ADDENDUM NO. 1

Job Name: **Noblesville City Hall Controls Upgrade**
Project Number: 24-800-036-1
Date of Addendum: **11/5/2024**

SECOND FLOOR MECHANICAL PLAN
M220
1/8" = 1'-0"

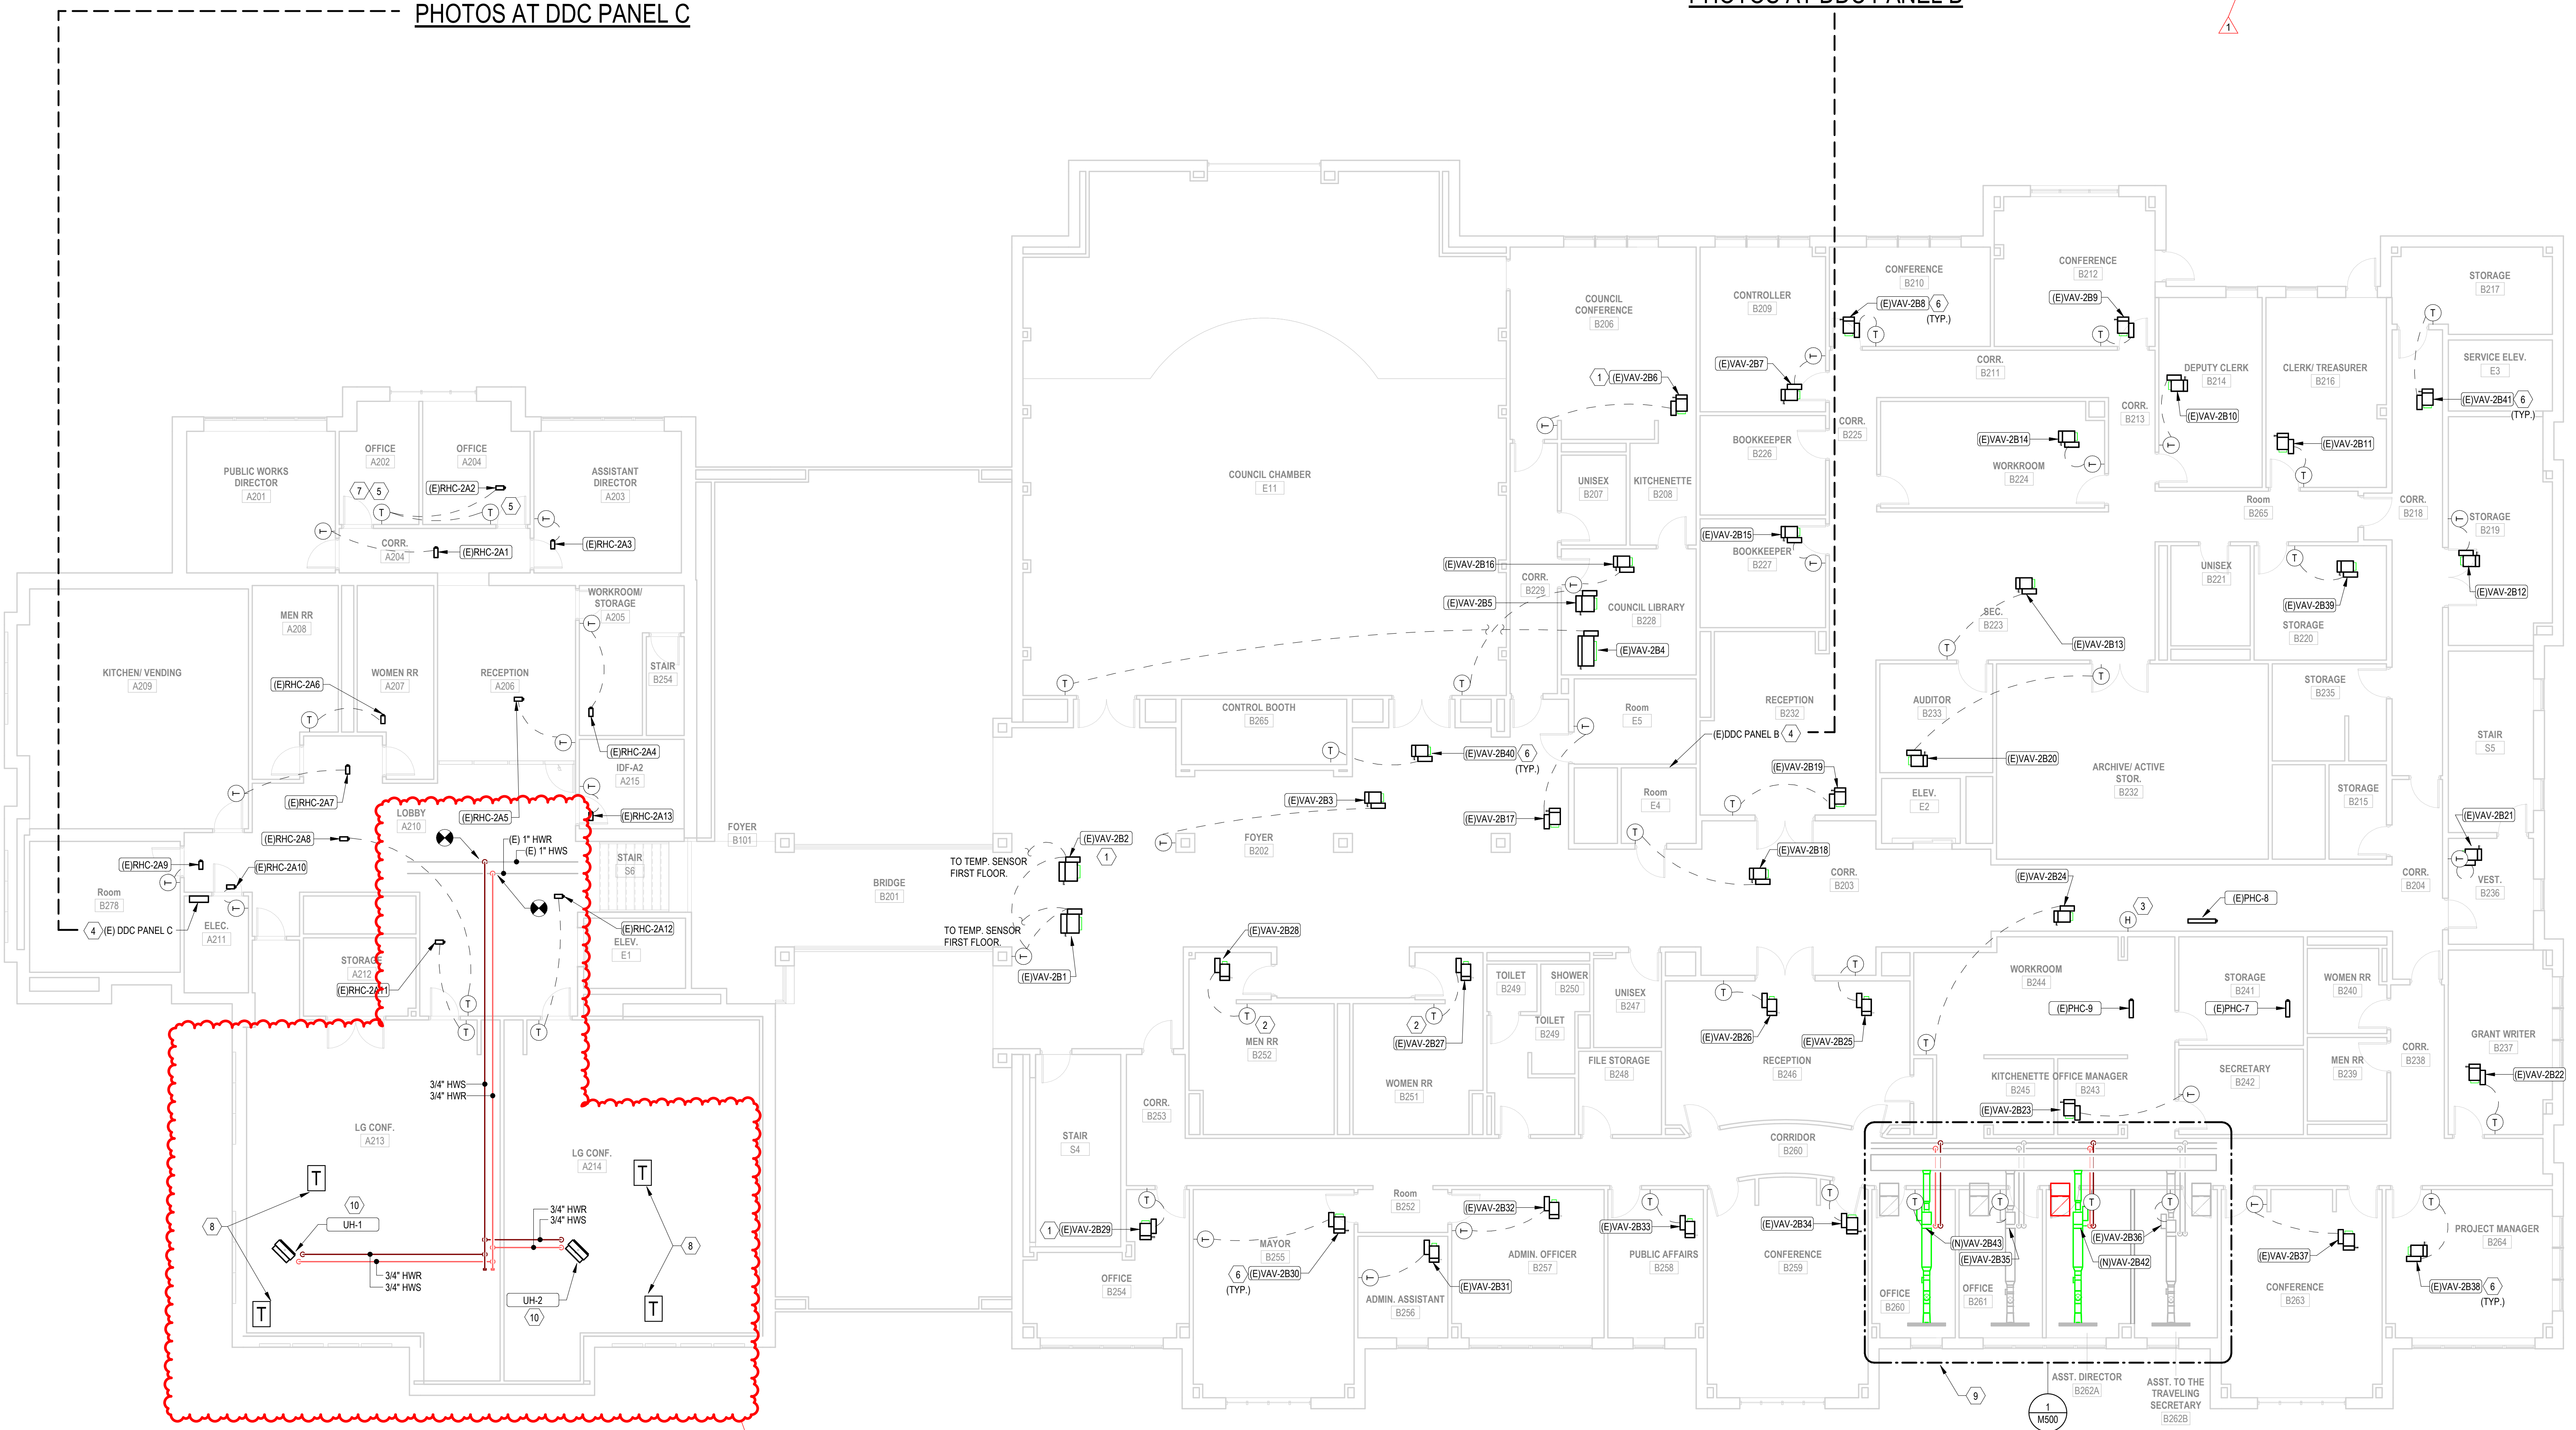
1. **Revise** Sheet M220
 - a. Added Unit Heaters above the ceilings of Lg. Conference Rooms A213 and A214.
2. **Revise** Sheet M500
 - a. Adjusted Entering Water Temperature on VAV box coils.
3. **Revise** Sheet M600
 - a. Added Unit Heater Schedule
4. **Add** Sheet E321
 - a. Provided Circuiting of new Unit Heaters
5. **Revise** Sheet P101
 - a. Updated RO system storage tank from 80 gallons to 120 gallons.
